Grid Code Modification Proposal Form <small>Email to gridcode@eirgrid.com</small>			
Title of Modification Proposal: MPID 286 Correction of Connection Voltage Graphs for 110kV and 220kV Systems under CC.7.3.6.5 MPID (EirGrid Use Only): 286			
Date:	16 October 2020		
Company Name:	EirGrid		
Applicant Name:	Niamh Daly		
Email Address:	Niamh.Daly@eirgrid.com	Tel:	+353 (0)1 677 0897
Grid Code Version:	8.1		
Grid Code Section(s) Impacted by Modification Proposal:	CC.7.3.6.5		
Modification Proposal Justification: <p>The purpose of this modification is to correct an error in clause CC.7.3.6.5.</p> <p>CC.7.3.6.5 shows a maximum voltage withstand capability of 1.118 p.u. for connections at 110 kV and 220 kV. In the case of 110 kV and 220 kV, this would require equipment to have the capability to continually withstand 123 kV and 246 kV respectively.</p> <p>As per clause CC.8.3.2, the maximum transmission system voltages during a transmission fault for 110 kV and 220 kV are nominally 123 kV and 245 kV respectively. This equates to an upper voltage limit of 1.118 p.u. for 110 kV transmission systems and 1.114 p.u. for 220 kV transmission systems. The values in clause CC.7.3.6.5 should be align

110kV Connection Voltage

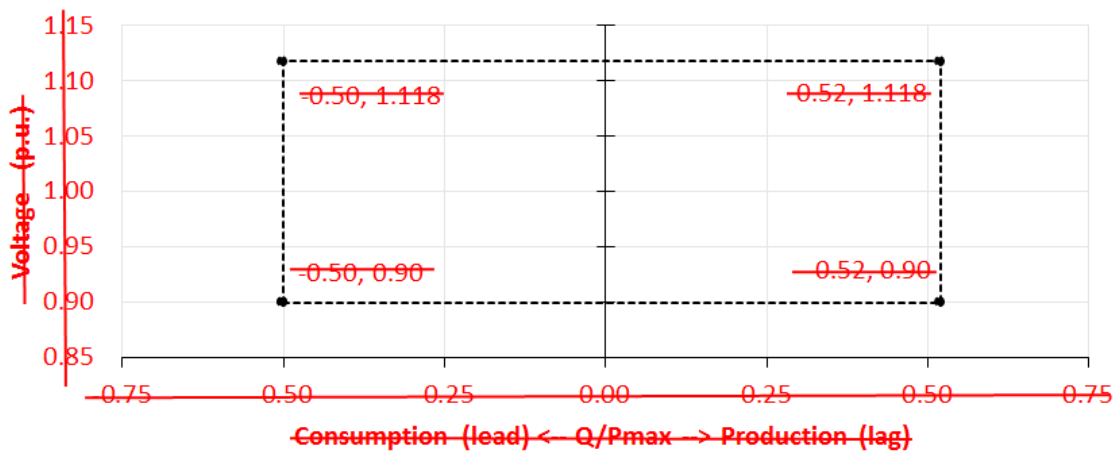
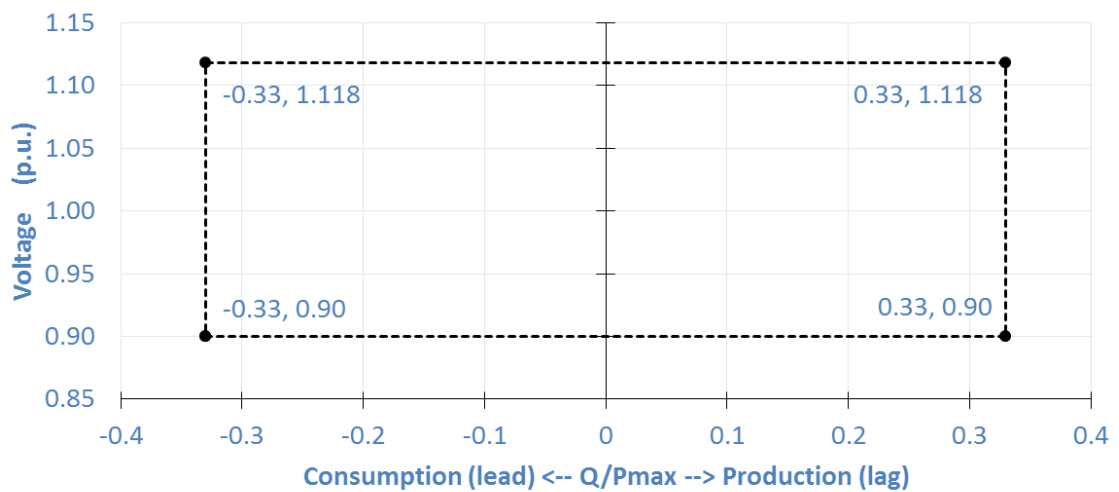
~~110kV and 220kV Connection Voltage~~
